35/13-04I-r14,Grafton,Street 04I  
Chevy,Chase,Village,Historic,District

**HISTORIC PRESERVATION COMMISSION STAFF REPORT**

<b>Address:</b>	14 Grafton Street, Chevy Chase Village	<b>Meeting Date:</b>	03/10/04
<b>Resource:</b>	Contributing Resource Chevy Chase Village Historic District	<b>Report Date:</b>	03/03/04
<b>Review:</b>	HAWP	<b>Public Notice:</b>	02/25/04
<b>Case Number:</b>	35/13-04C	<b>Staff:</b>	Michele Naru
<b>Applicant:</b>	James Guerra/Nicole Vanasse (Paul Locher, Agent)	<b>Tax Credit:</b>	N/A
<b>Proposal:</b>	Construct two major additions		
<b>Staff Recommendation:</b>	Approve with conditions

Re: Historic Area Work Permit # 329109  
14 Grafton Street, Chevy Chase, MD  
Contributing Resource within the *Chevy Chase Village Master Plan Historic District*

4 GRAFTON STREET  
HARDSCAPE PLAN

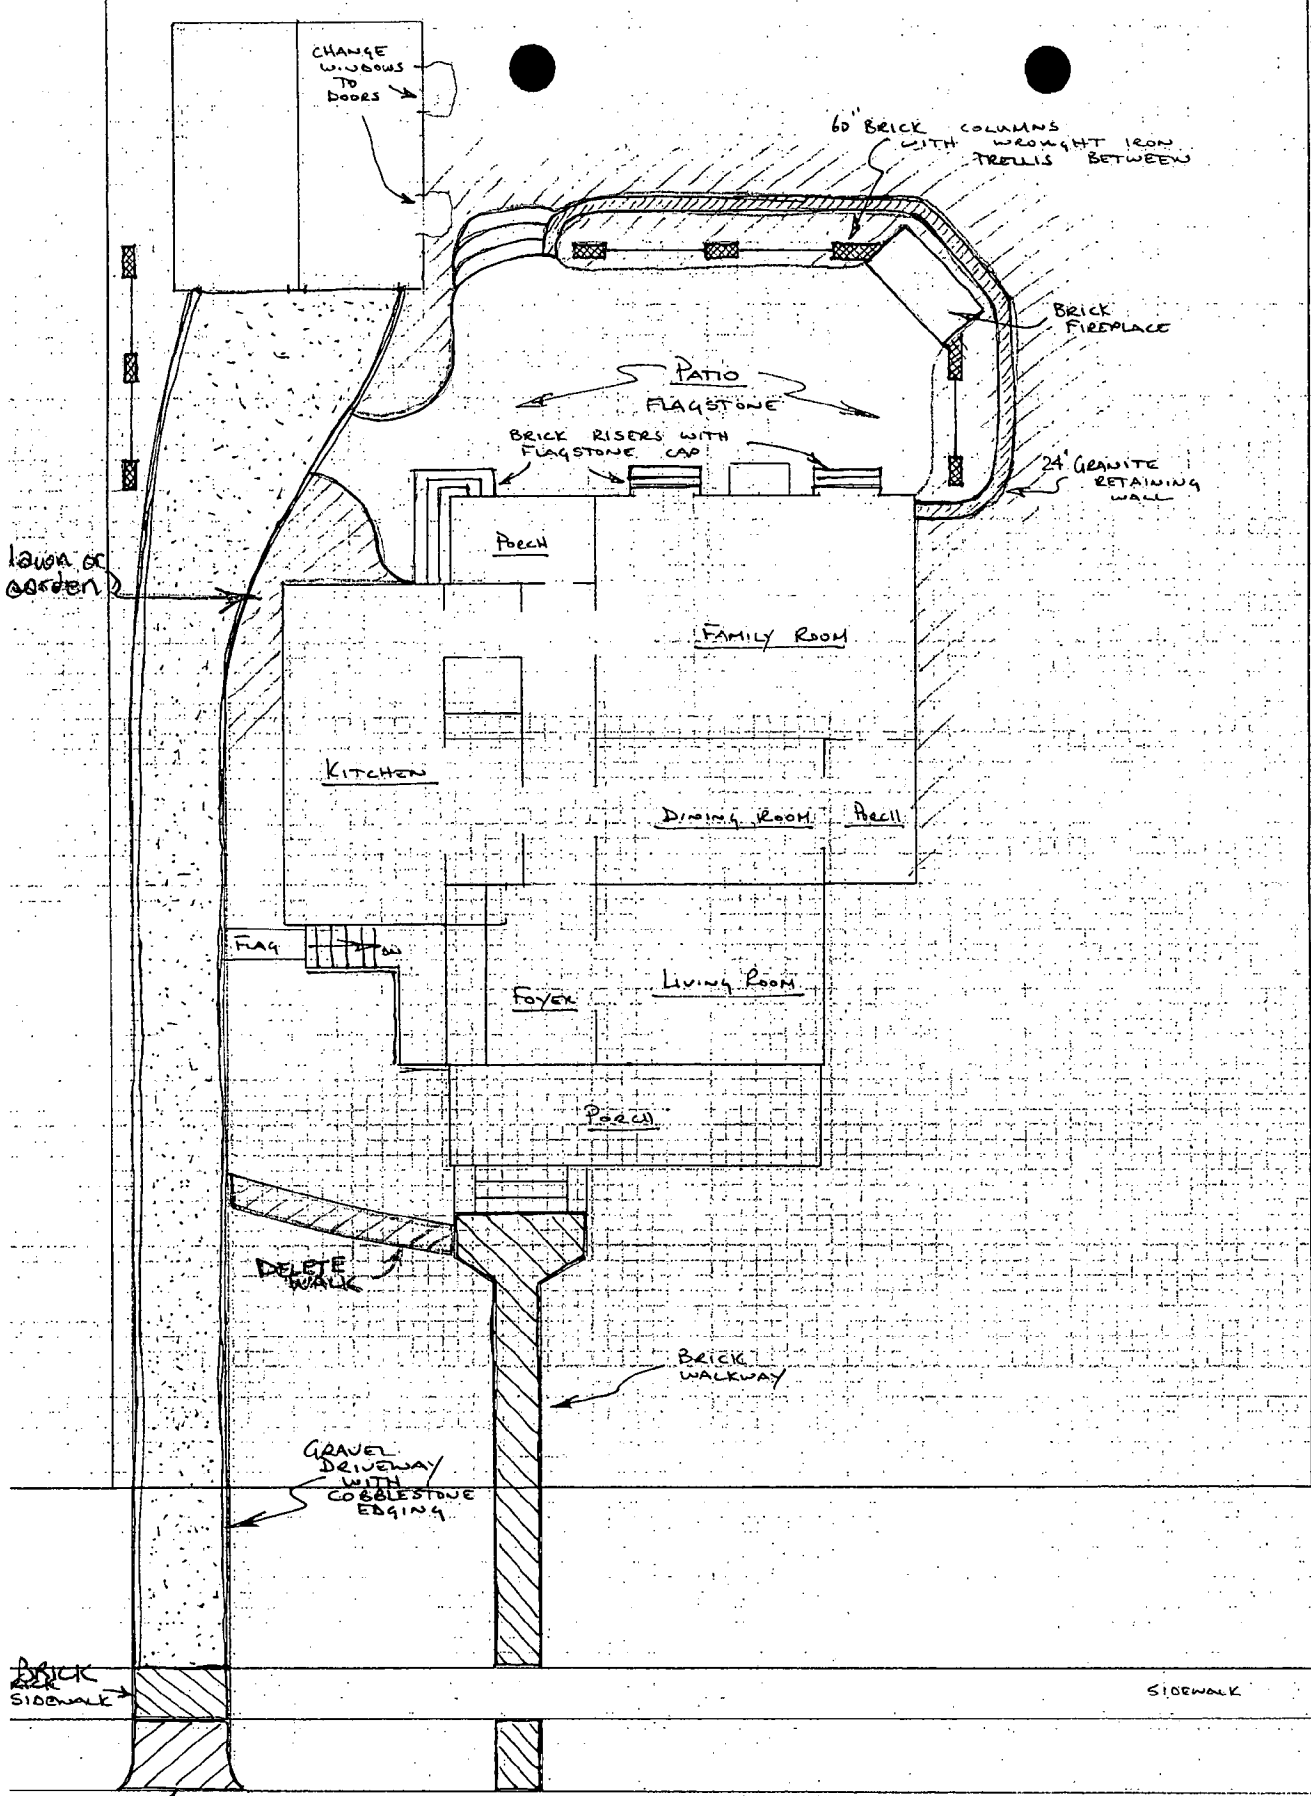
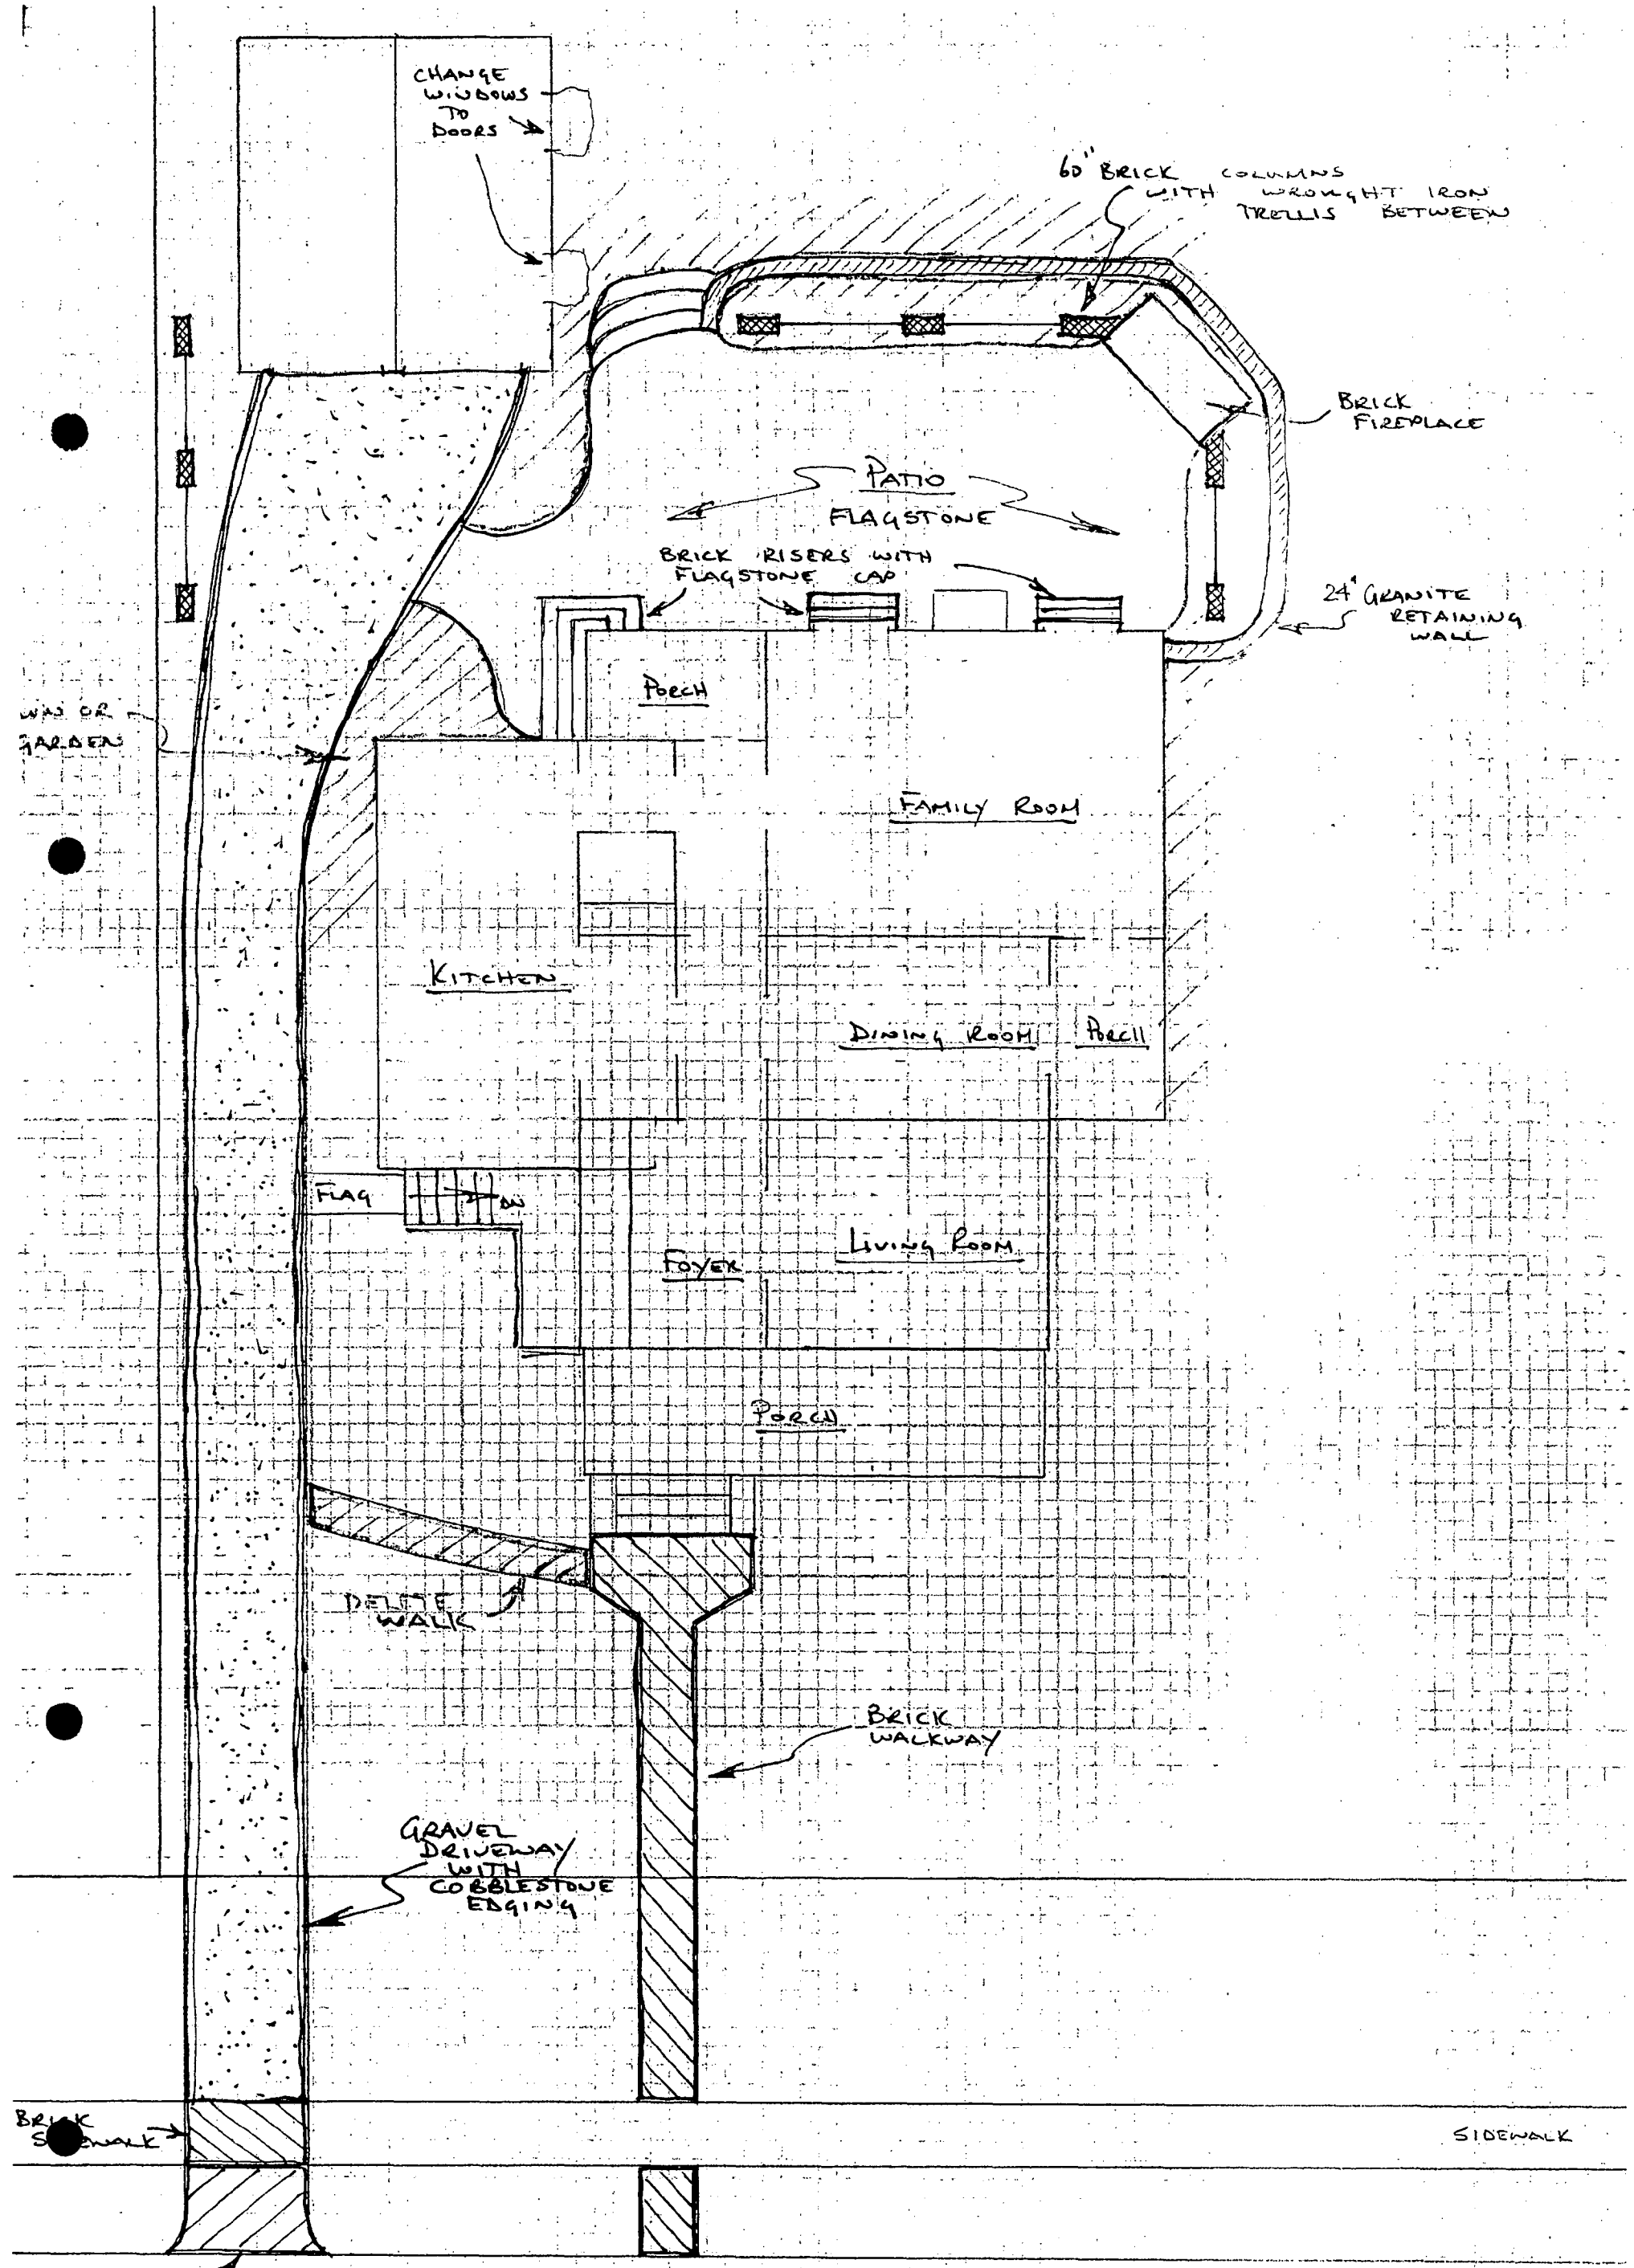
- ① REVISED HARDSCAPE PLAN  
UPDATED FROM ORIGINAL  
APPROVAL
- ② REQUEST TO REPLACE FRONT  
DOOR TO SIMPSON # 7662

CHANGE  
WINDOWS  
TO  
DOORS

DELETE  
WALK

*Hardscape Plan:* Staff compared the current hardscape proposal with the concept approved by the Commission in March. We believe that it is a more sensitive design than originally proposed and appears to have less non-organic surfaces. The materials proposed are natural and include brick walks, a gravel drive, and flagstone pavers. Two sections of wrought iron fencing with brick piers (5' high) are proposed in the rear yard, as is a 2' high granite retaining wall. Since each of these items is subject to moderate or lenient scrutiny under the *Chevy Chase Village Historic District Guidelines*, staff believes the plan to be compatible and approvable.
